RE: **Albuquerque School of Excellence Expansion**
13201 Lomas NE
Grading and Drainage Plan Stamp Date: 11/7/19
Hydrology File: J22D050

Based on the submittal received on 11/8/19, the grading and drainage plan cannot be approved until the following corrections are made:

ENGINEER'S SEAL	DRAWN BY pm
	ABQ SCHOOL OF EXCELLENCE	DATE 11-5-19
	OVERALL GRADING AND DRAINAGE PLAN	DRAWING 2019068-GR
	 5571 MIDWAY PARK PL NE ALBUQUERQUE, NEW MEXICO 87109 (505) 858-3100 www.tierrawestllc.com	SHEET # GR-1 JOB # 2019068

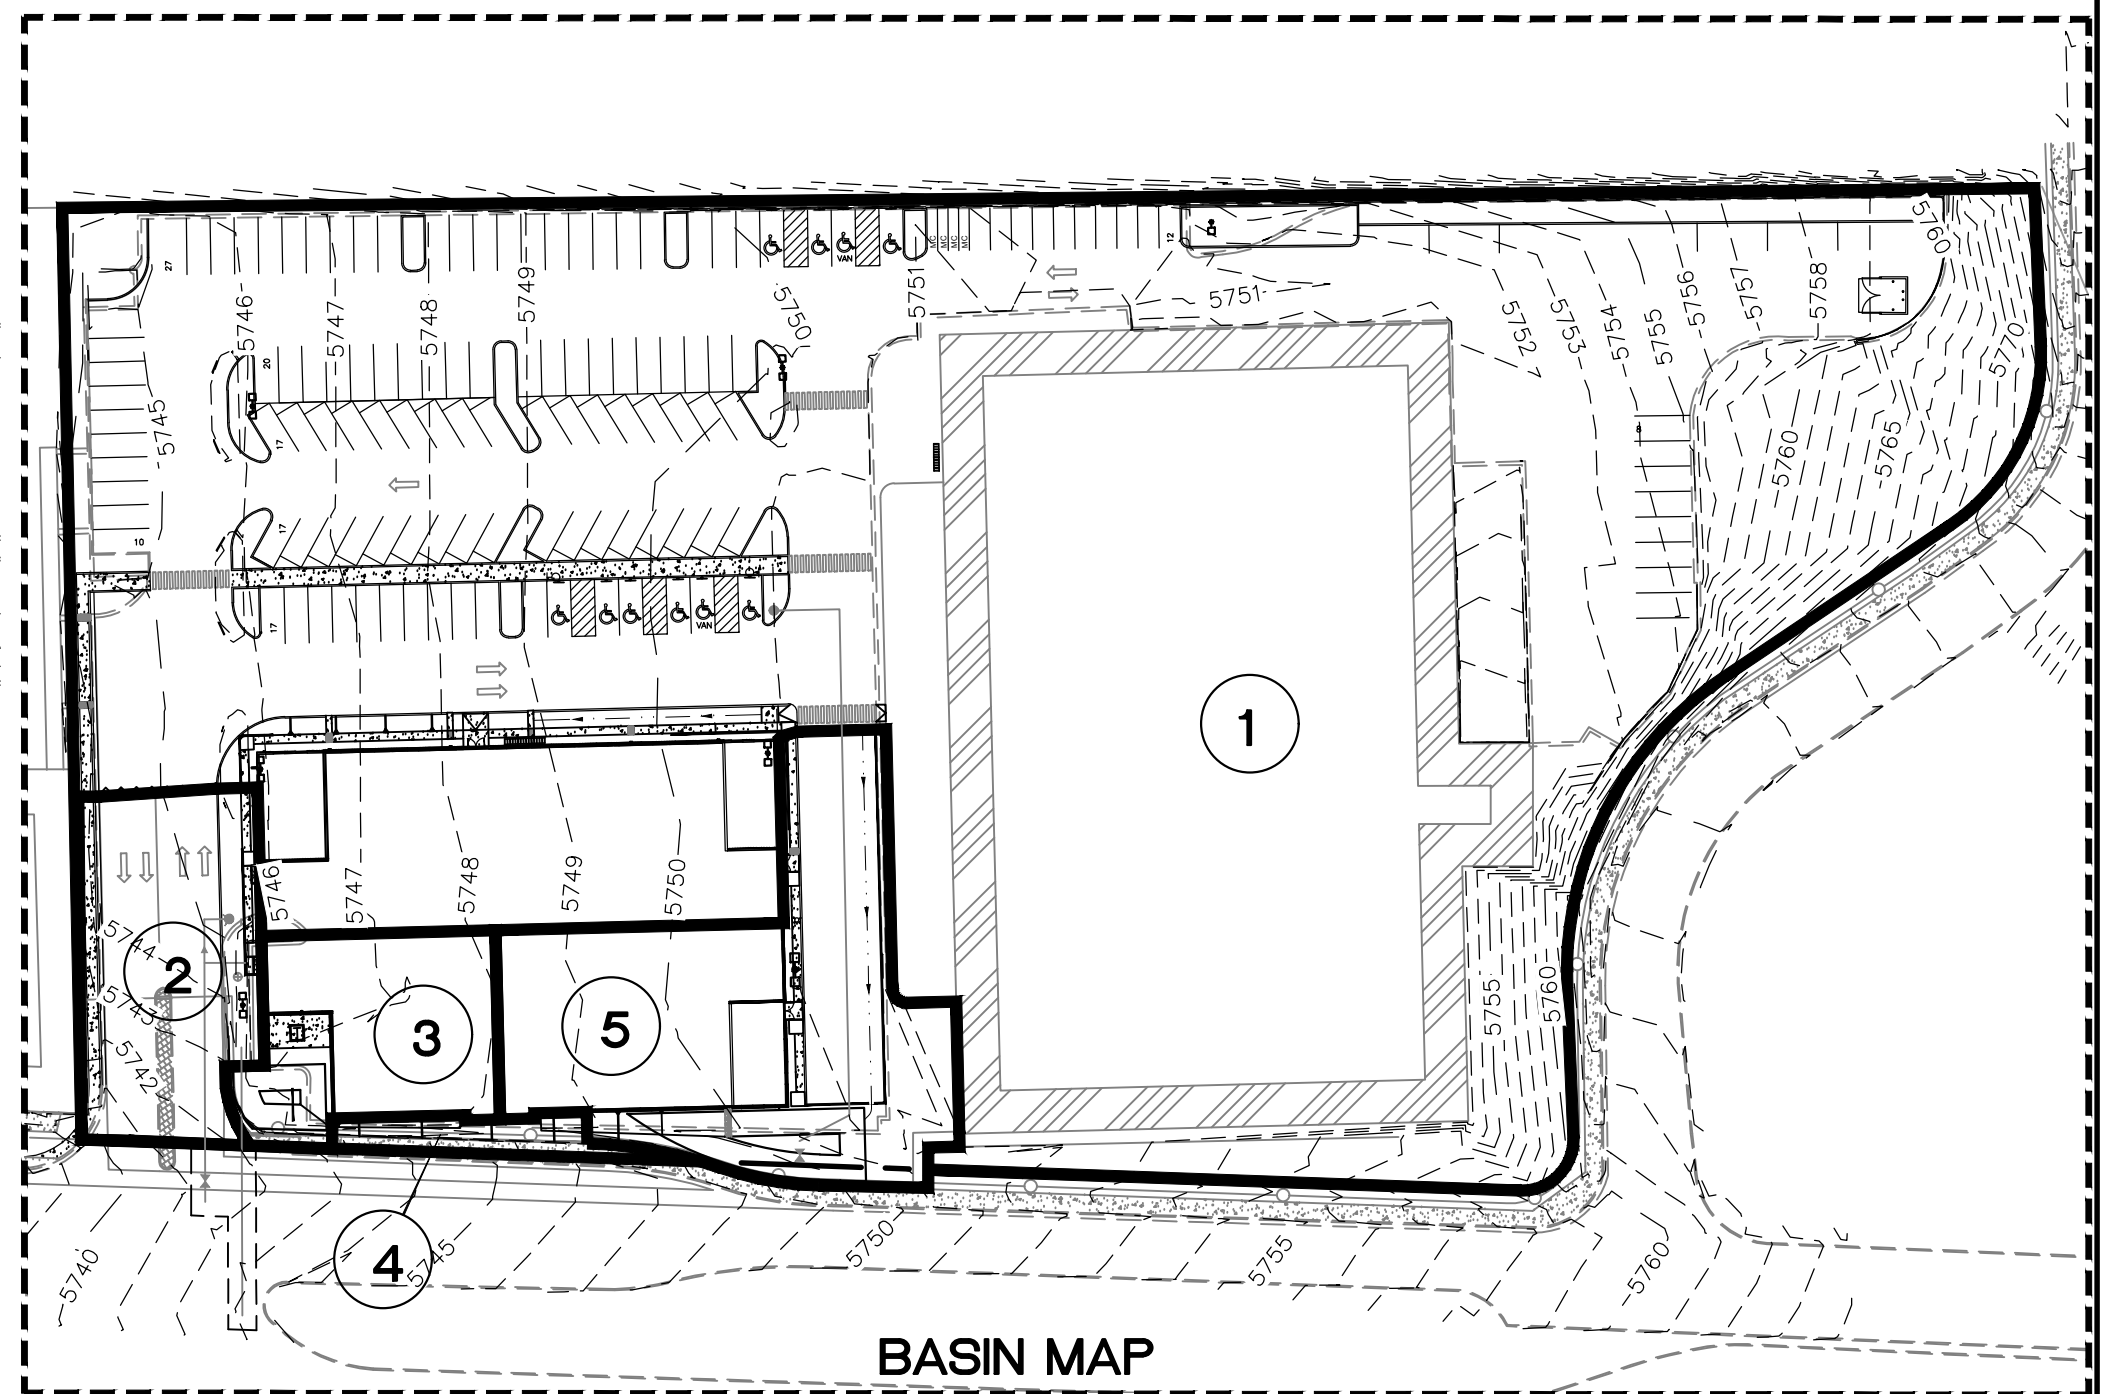
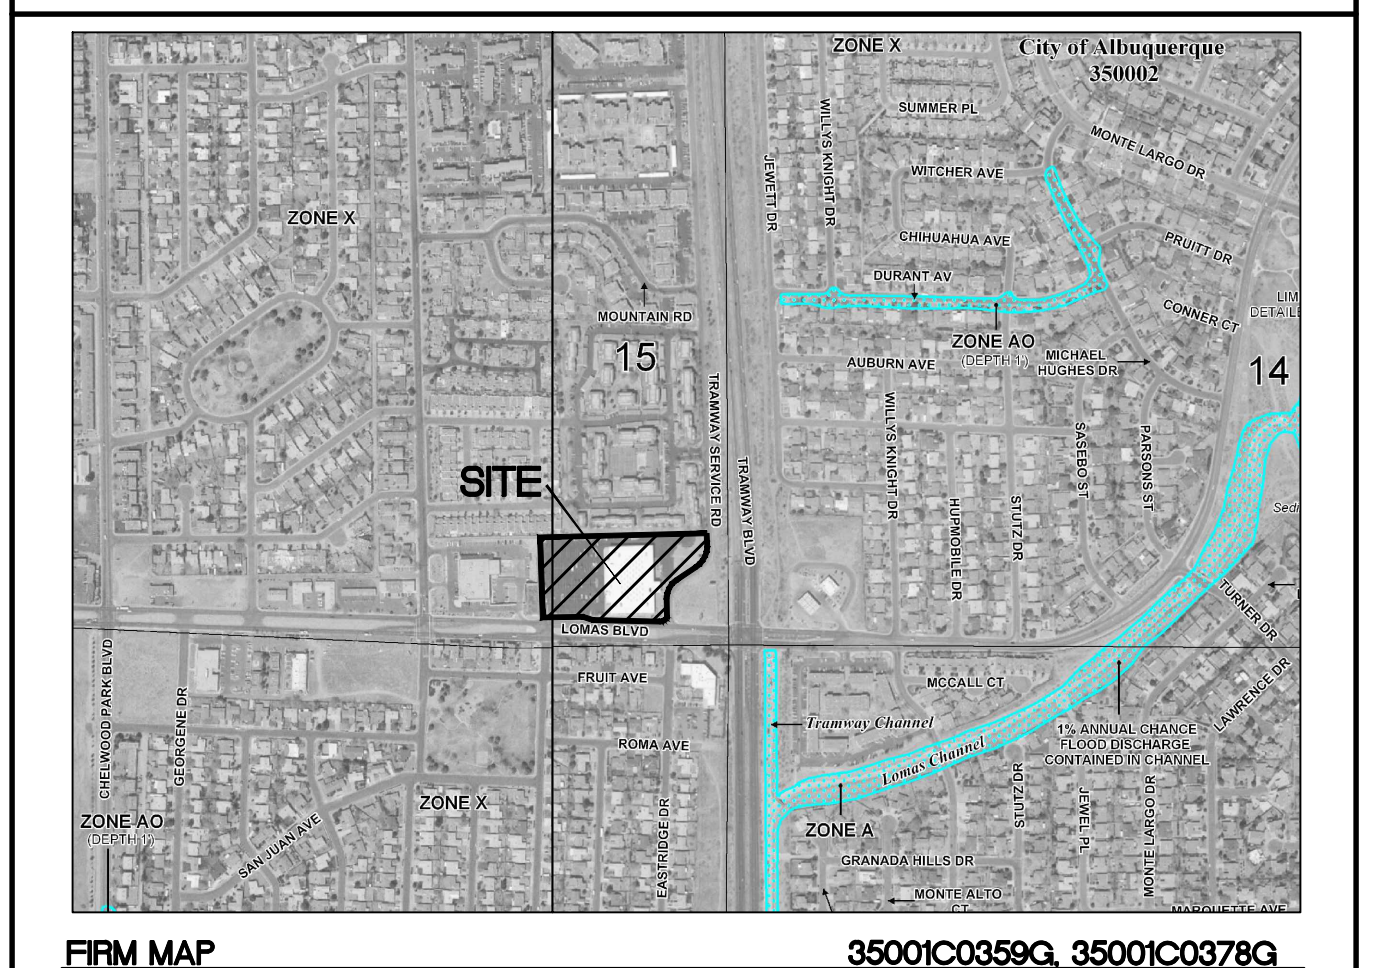
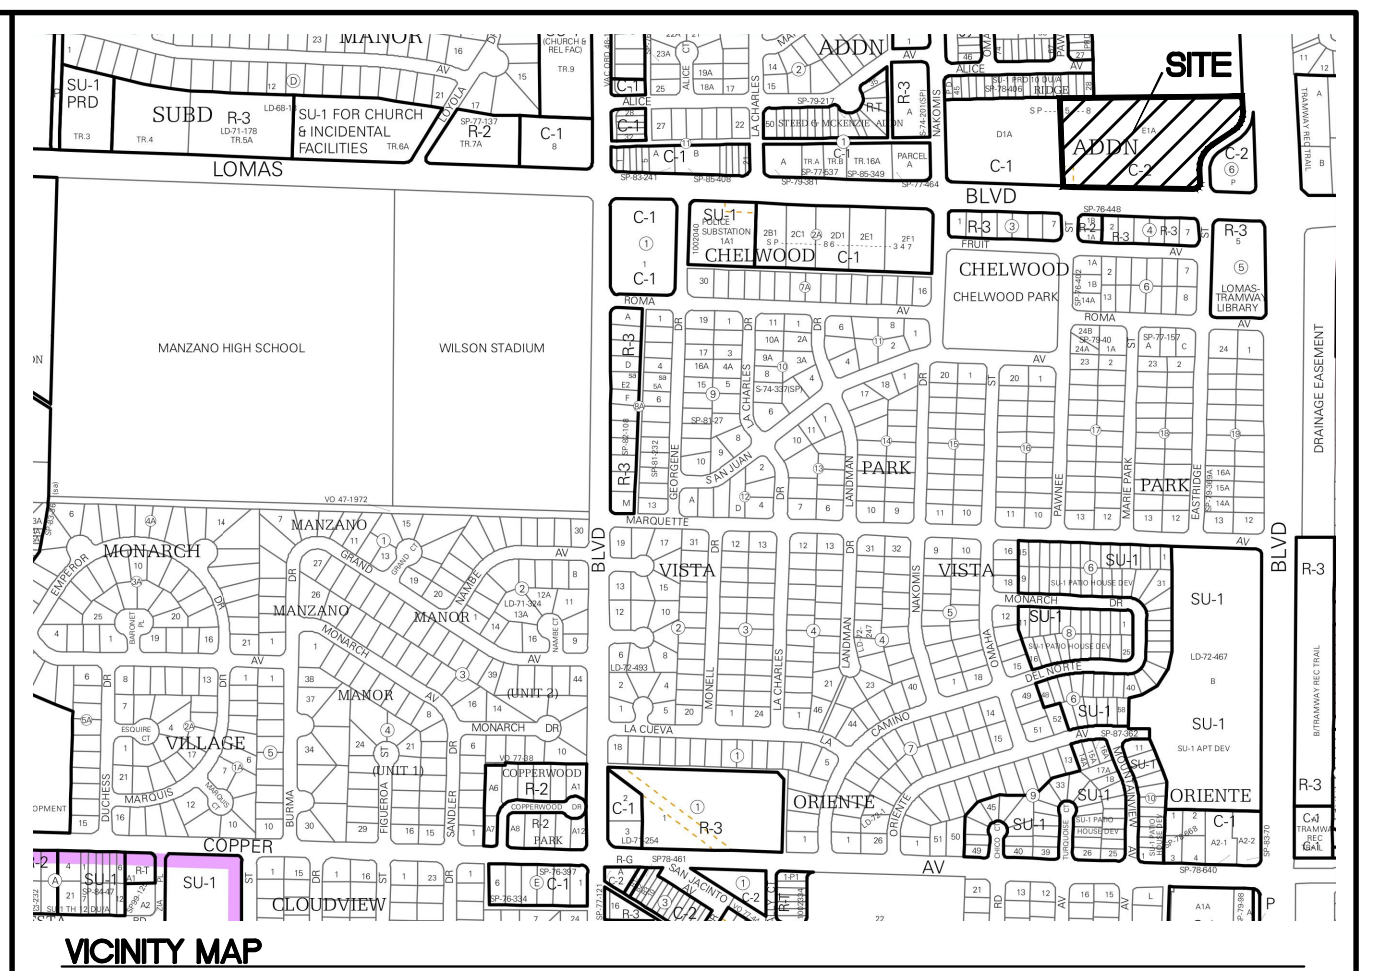
1. Please number the ponds and include sections and labels on each with the Stormwater Quality Volume (SWQV) and elevation, the 100-year volume and elevation, the peak 100 year inflow, top of pond elevation. Provide pond volume calculations by contour area; correct the volume on the western pond.

3. The eastern (and western) pond cannot encroach on the ROW.
4. Provide a section through the proposed building and Lomas. Provide stabilization of slopes exceeding 3:1. There's one stem wall elevation called out as $\text{TW} = 43.00$ that probably should be 49.66.

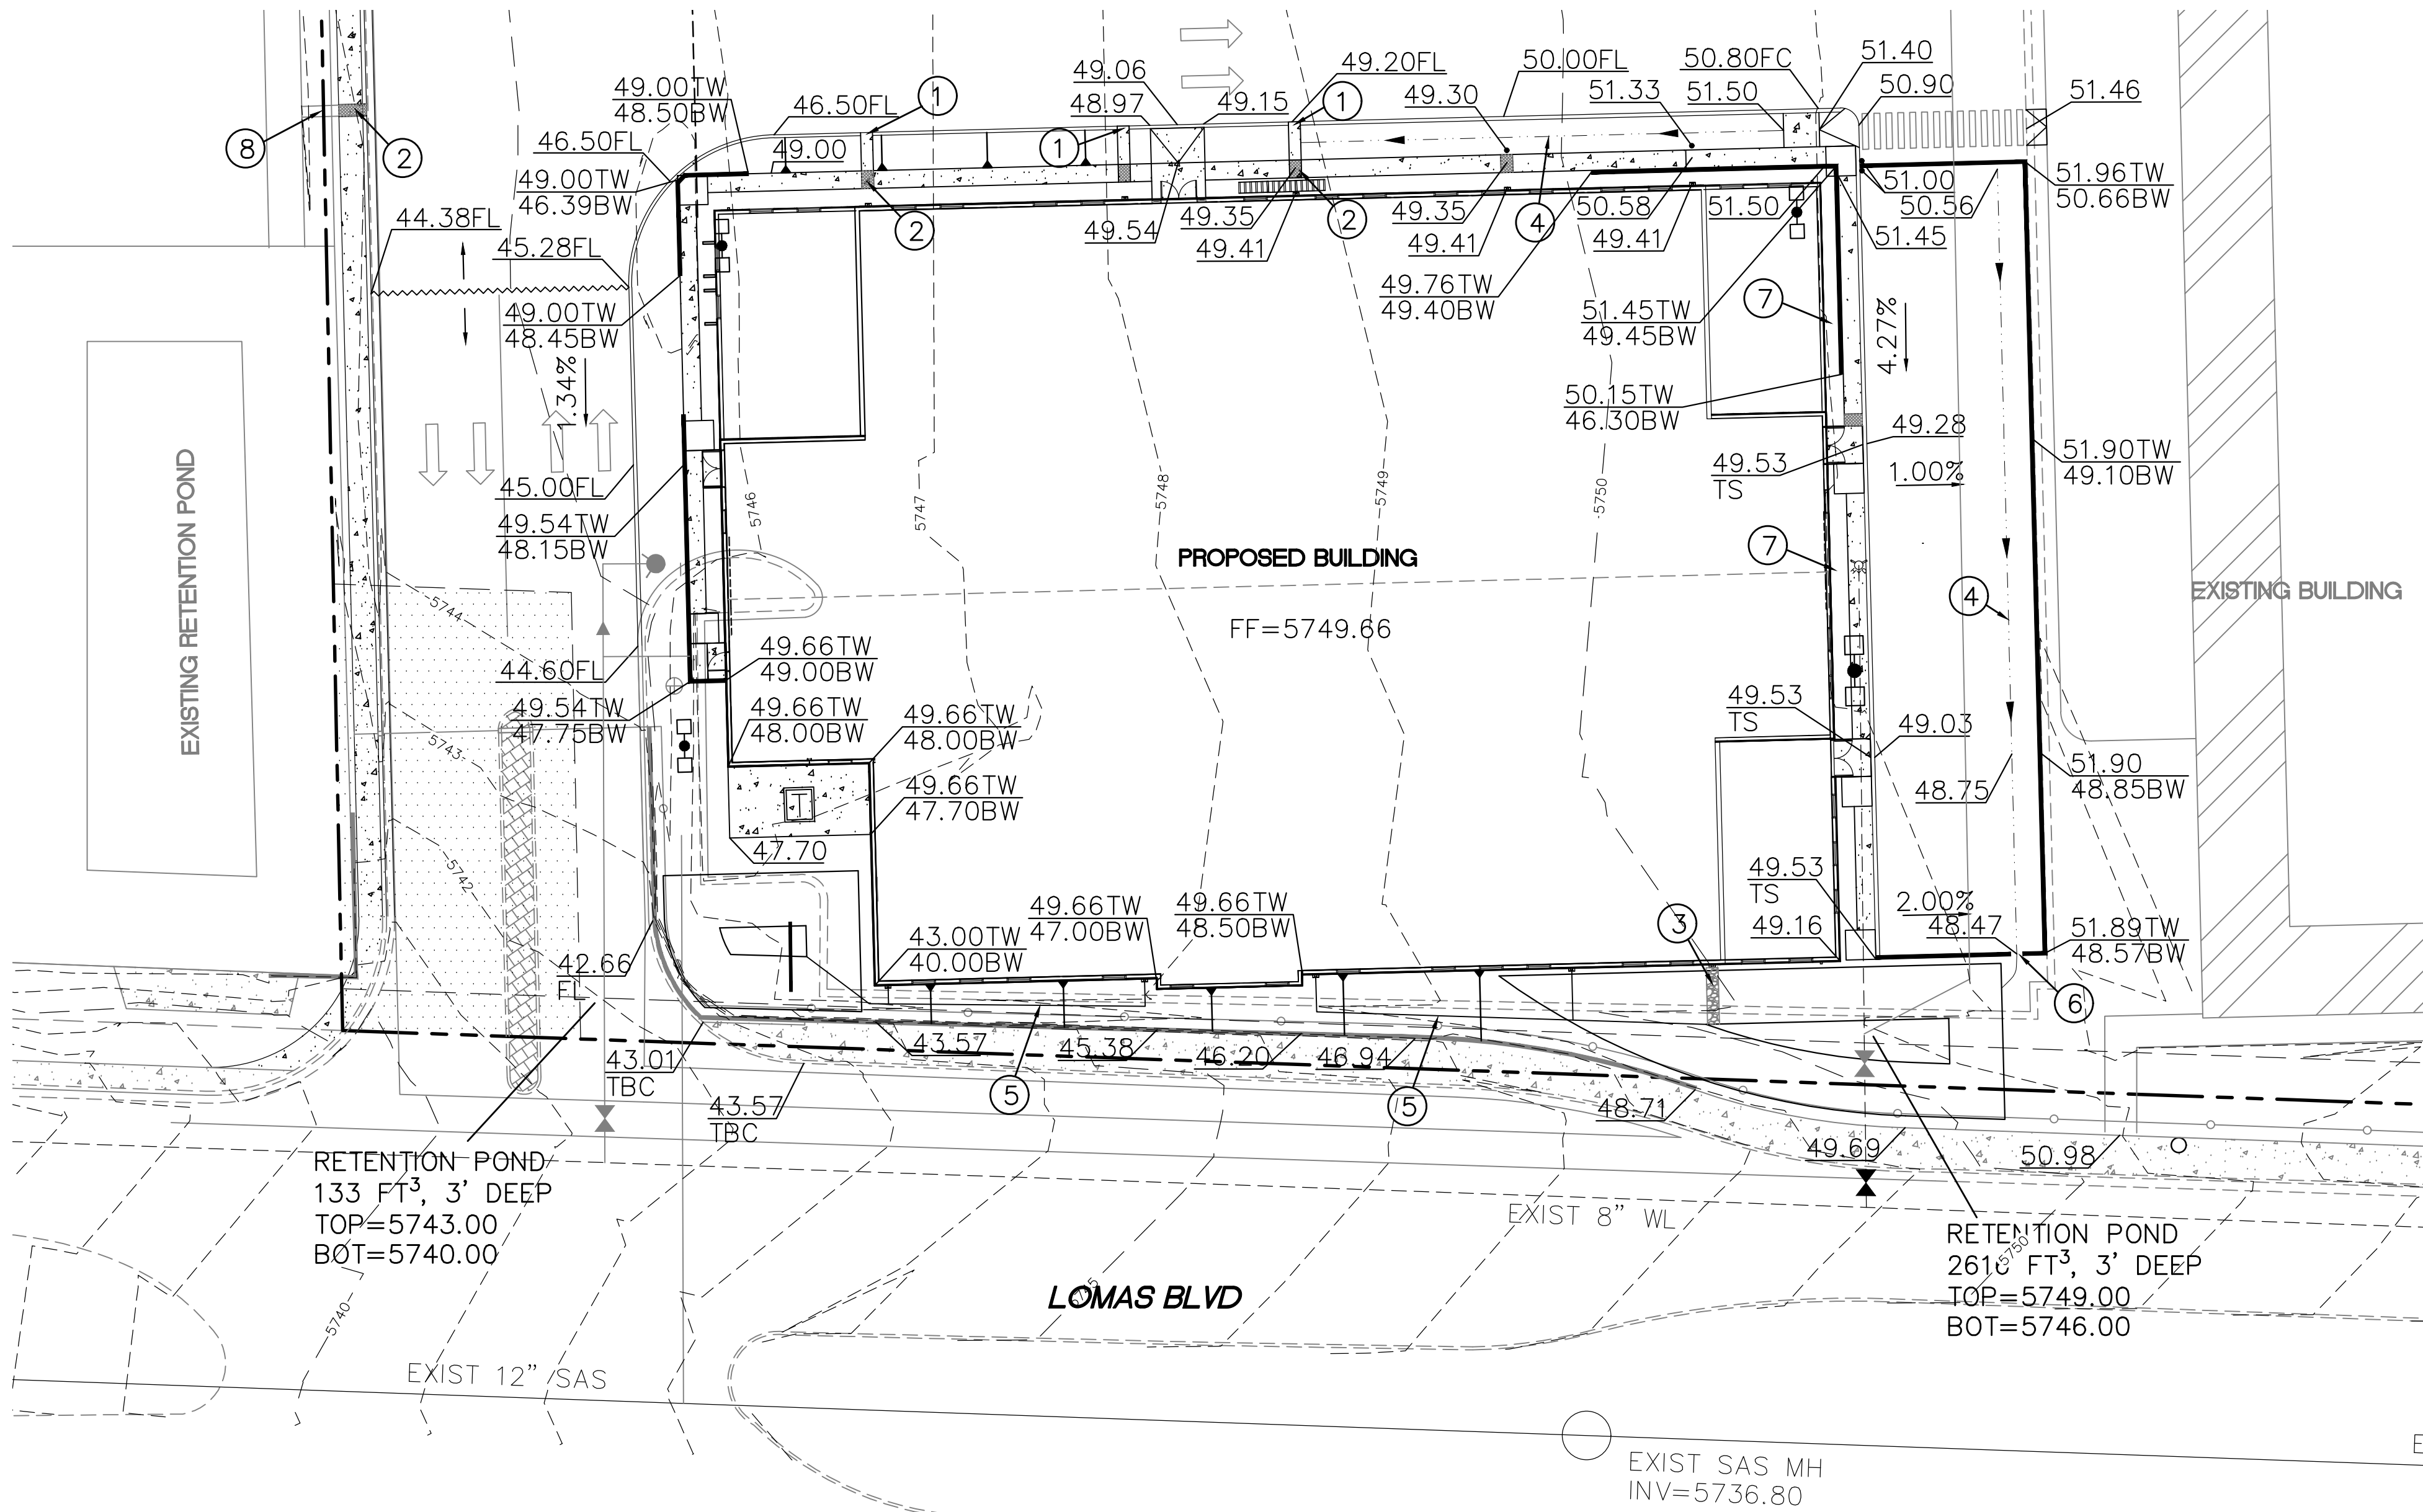
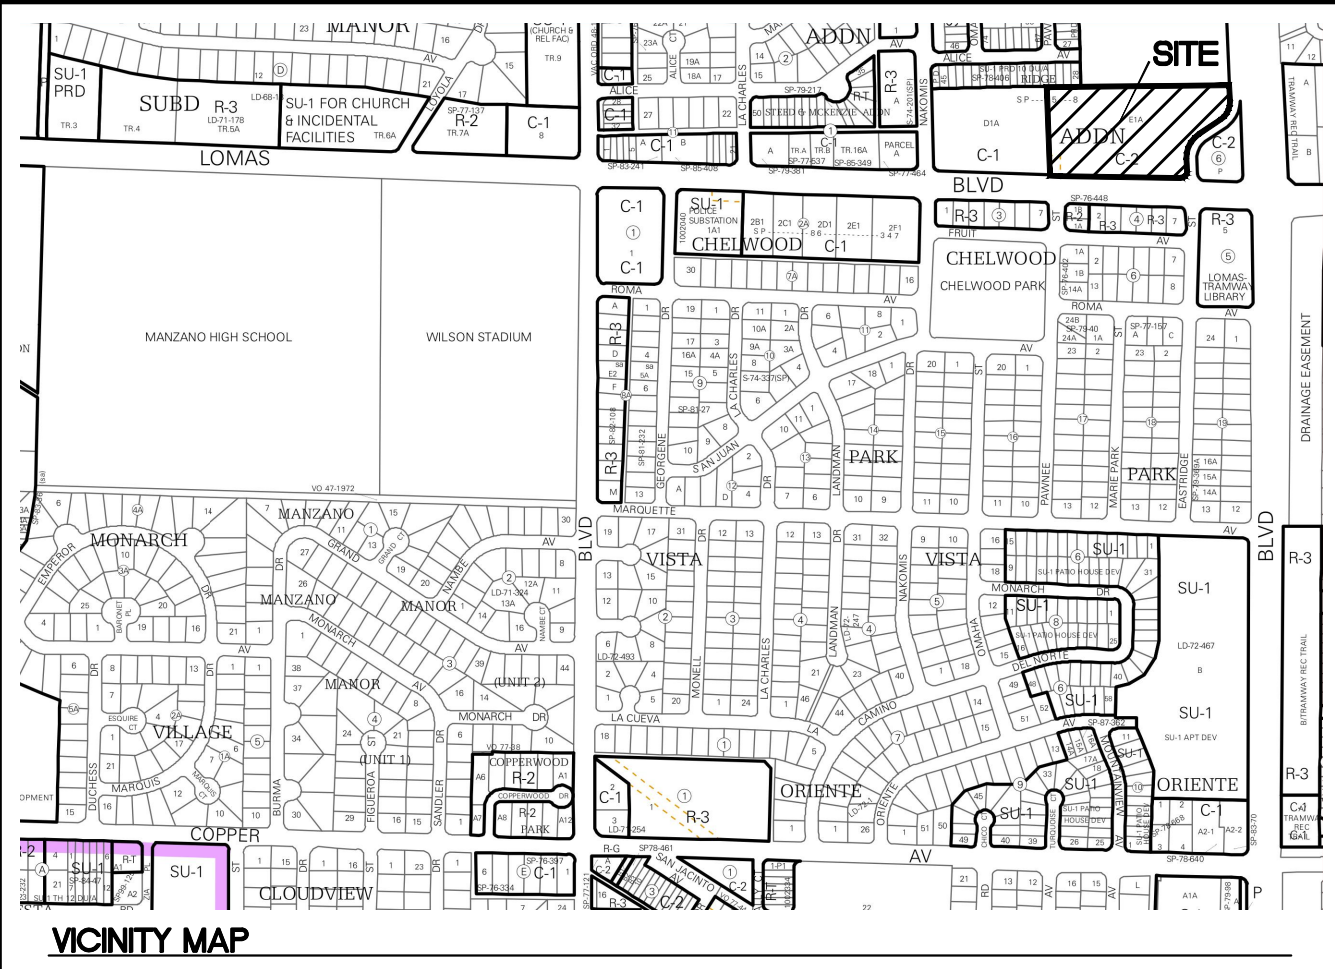
2. Please include the SWQV calculations. This site qualifies as redevelopment and is only required to retain runoff from the 80th percentile storm ($\text{Vol.} = 0.26'' * \text{Imp. Area}$).
